PLANNING COMMISSION AGENDA

1. **JSP25-0012 NOVI ACRES**

NOVI ACRES
JSP 25-0012

Required Action
Recommend approval/denial of the Preliminary Site Plan and Amendment to the Consent Judgment to the City Council.

DRAWING NUMBER:
L-1.0

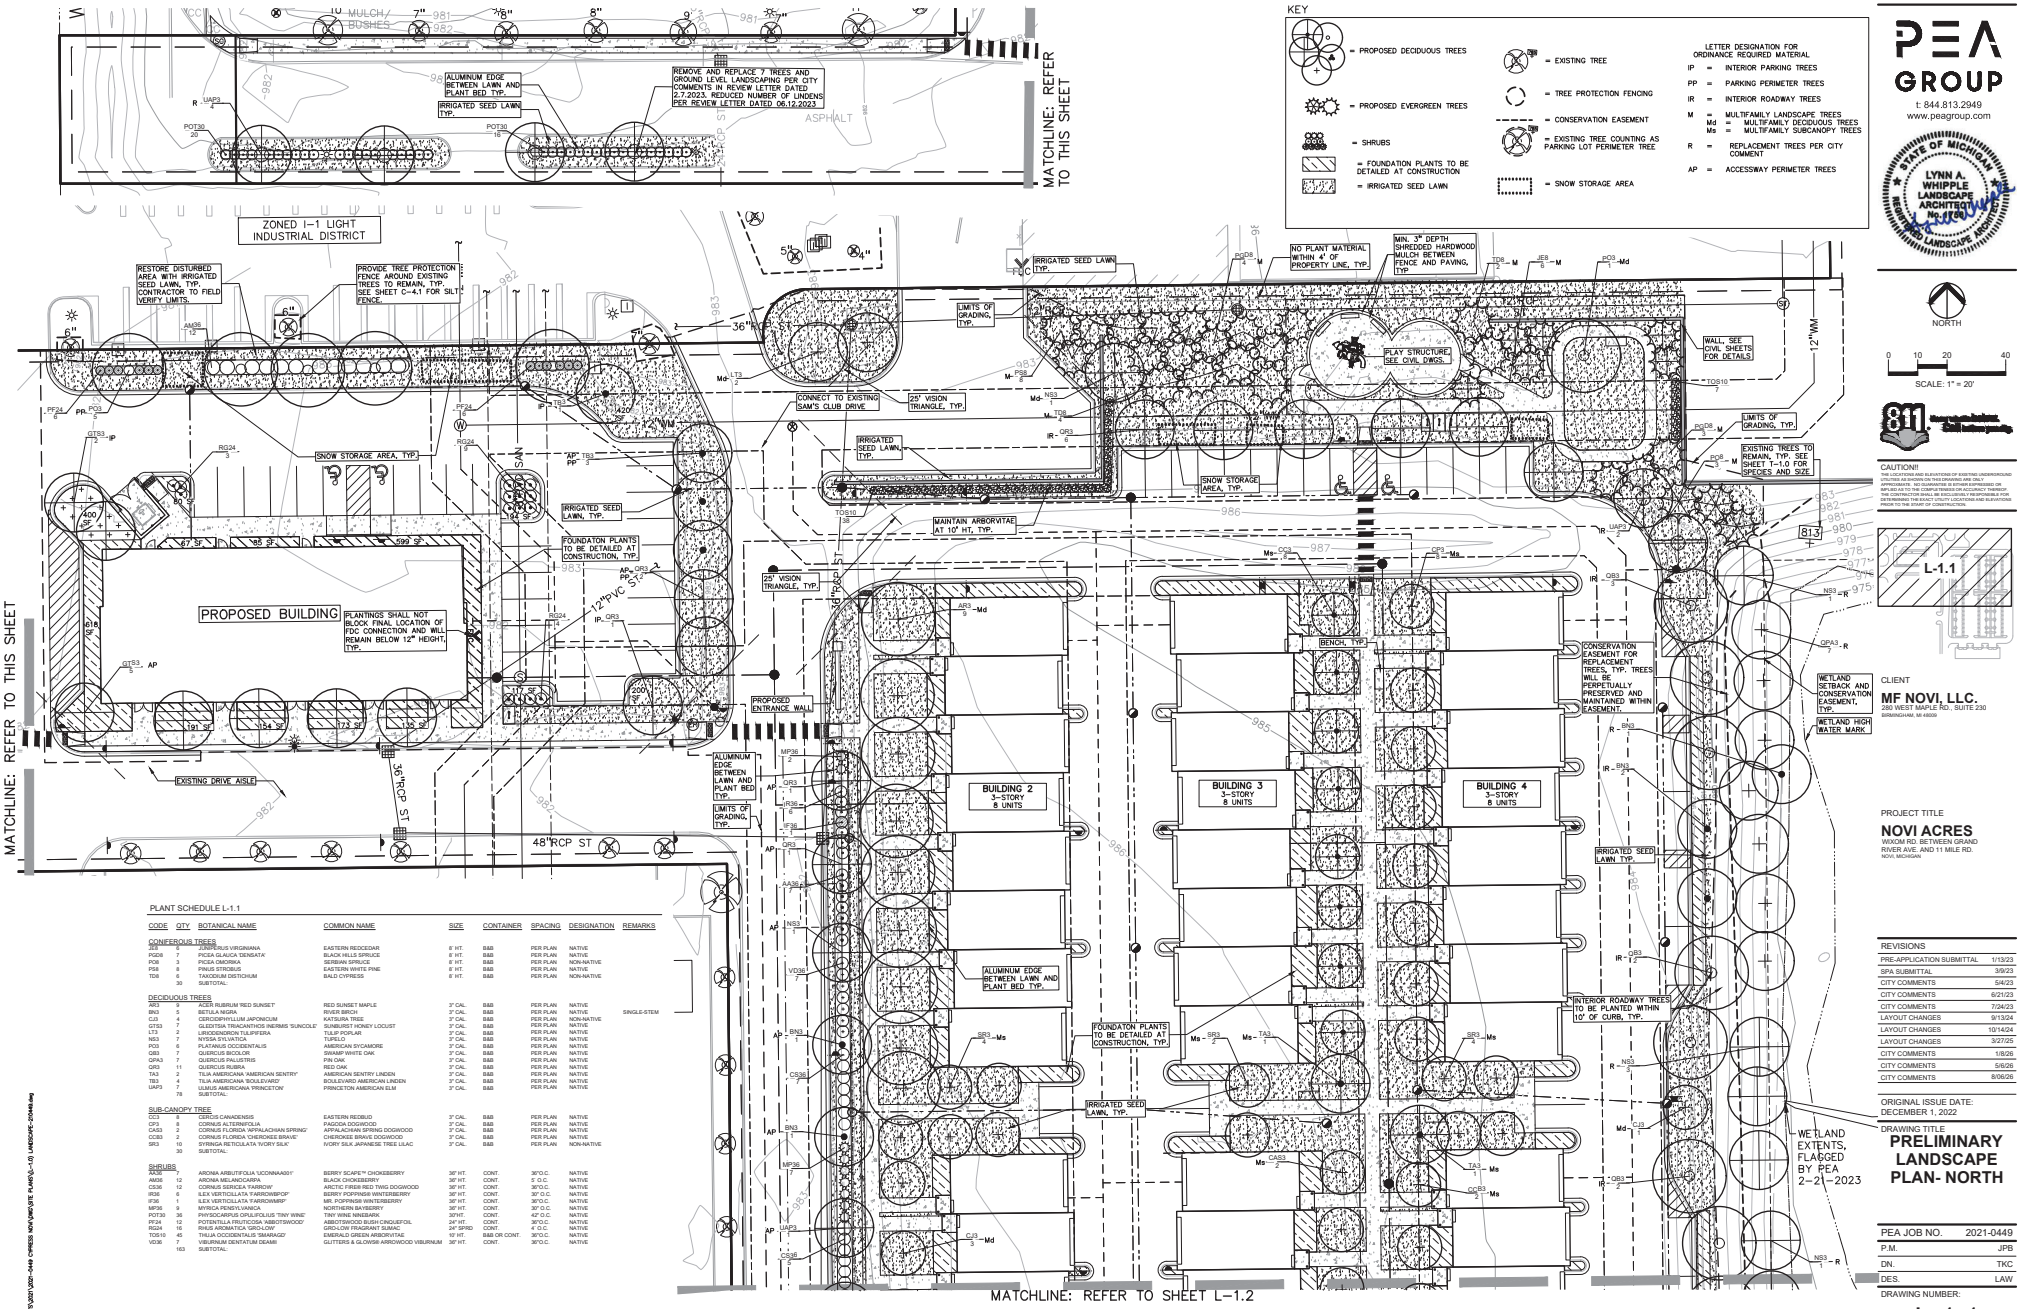
Soil type *(LDM 10)*	As determined by Soils survey of Oakland county	**Sheet L-1.0** • Marlette sandy Loam • Capac sandy loam • Houghton & Adrian mucks	Yes	
Zoning *(LDM 10)*	Show zoning of all adjacent parcels on the landscape plan	**Shown on C-3.0** • Site: I-1 with consent judgment • North, East, South, West: I-1	Yes	
PROPOSED IMPROVEMENTS *(LDM 10)*				
Existing and proposed improvements	Existing and proposed buildings, easements, parking spaces, vehicular use areas, and R.O.W	• Dimensions on Sheets C-3.0, 3.1 and 3.2 • All elements are included on the	Yes

DRAWING NUMBER:
L-1.2

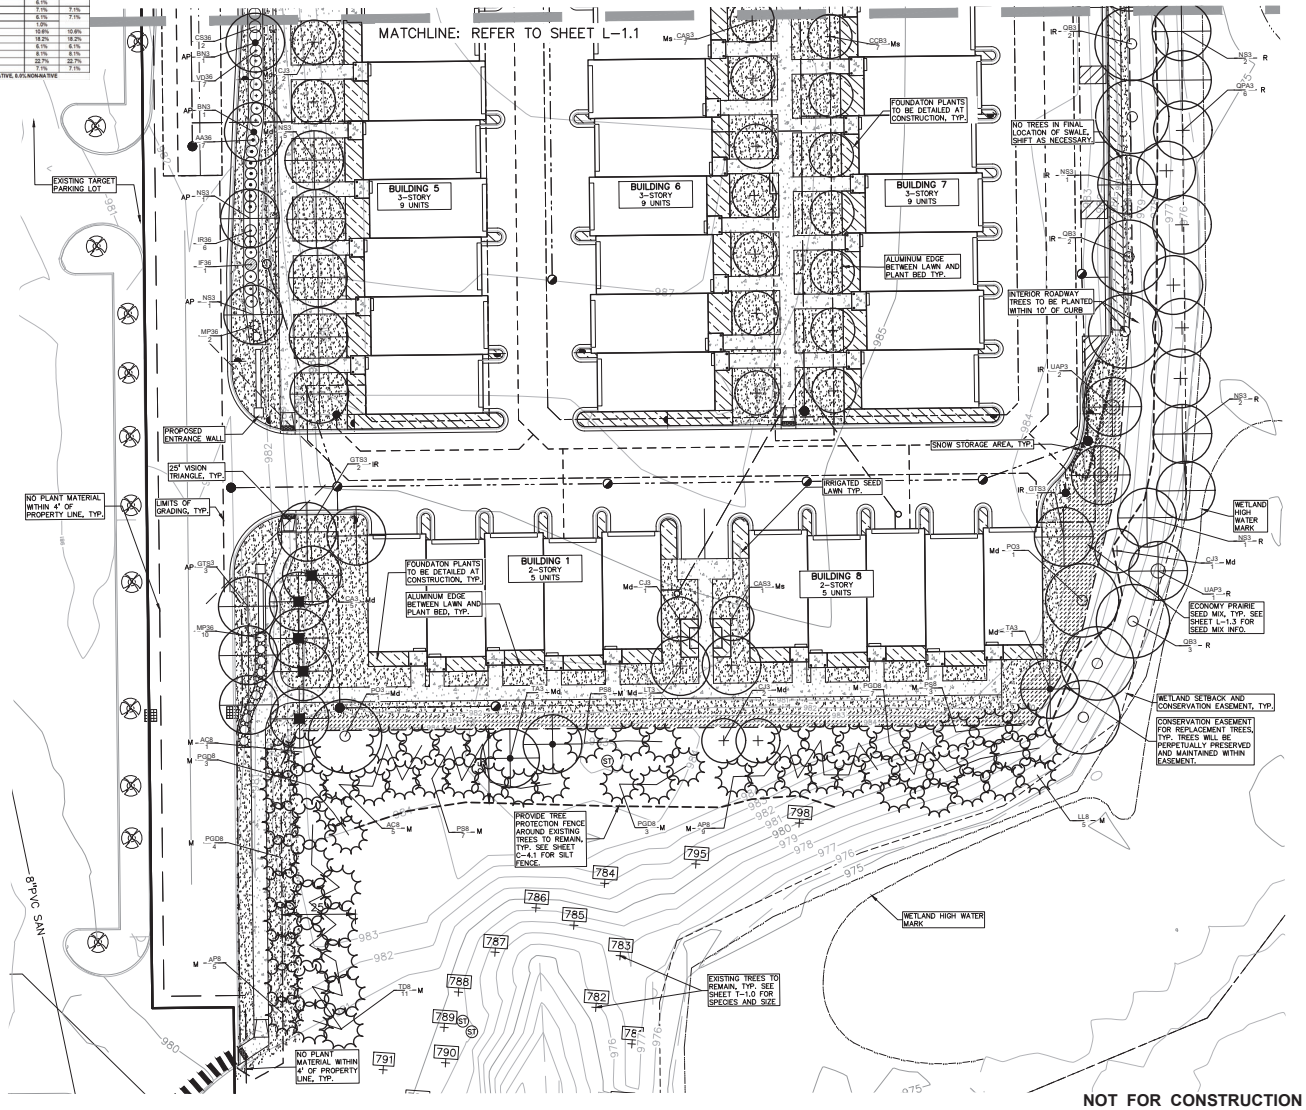
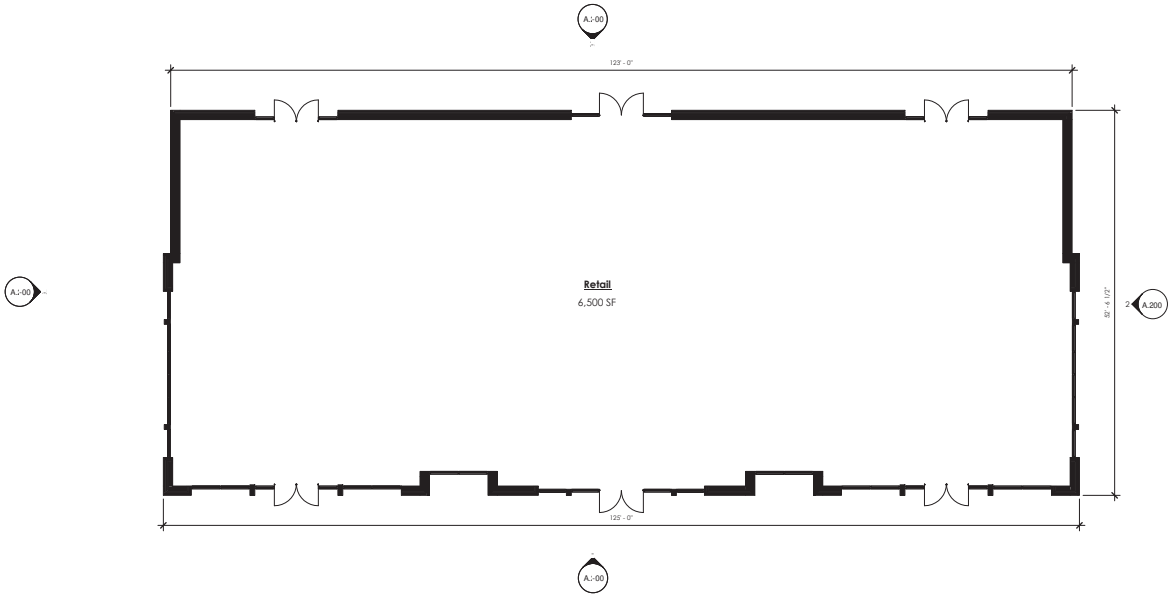
Our project is more akin to the urban concept residential which is what the Main Street project is. With this additional foundation landscaping for these four buildings we are now able to achieve 12% for Buildings 1 and 8; 13.13% for Building 4 and 13.33% for Building 7. See Site Plan Sheets L 1.1 and L 1.2 and the Toll Color Renderings.

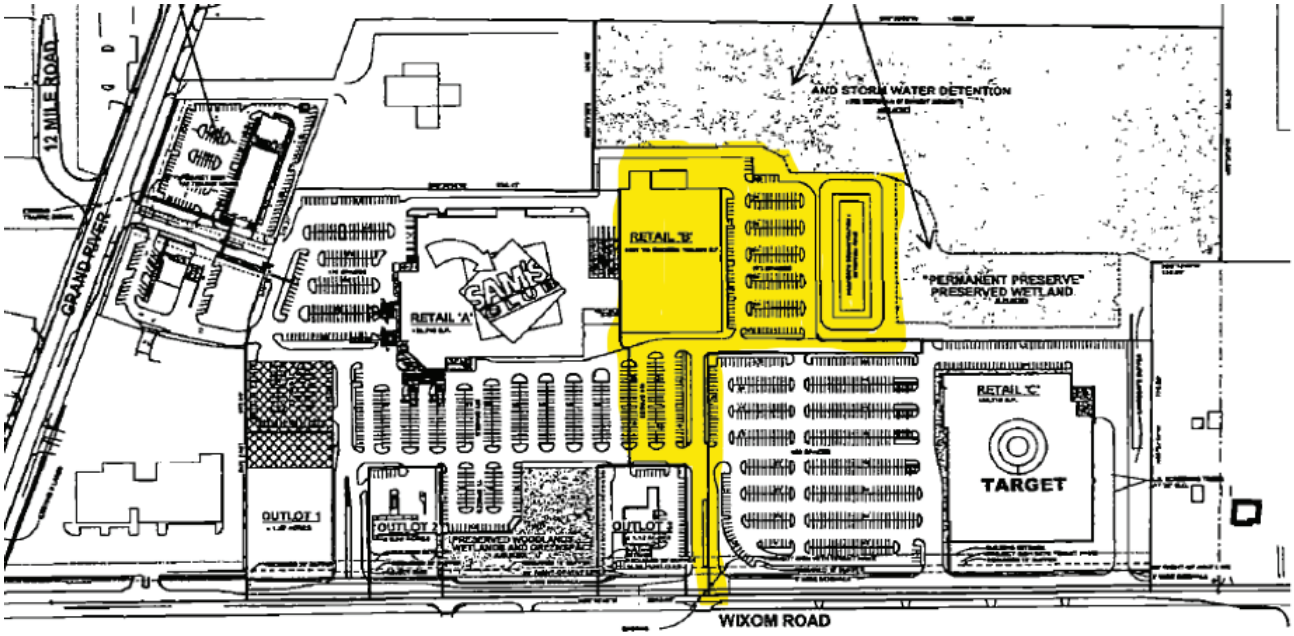
The Planning review letter and the associated chart identify several concerns (noted in bold and underline throughout the review letter) and request additional clarification or justification regarding the proposed use and its compatibility with surrounding uses. The applicant's revised letter submitted with this application does not address these concerns.
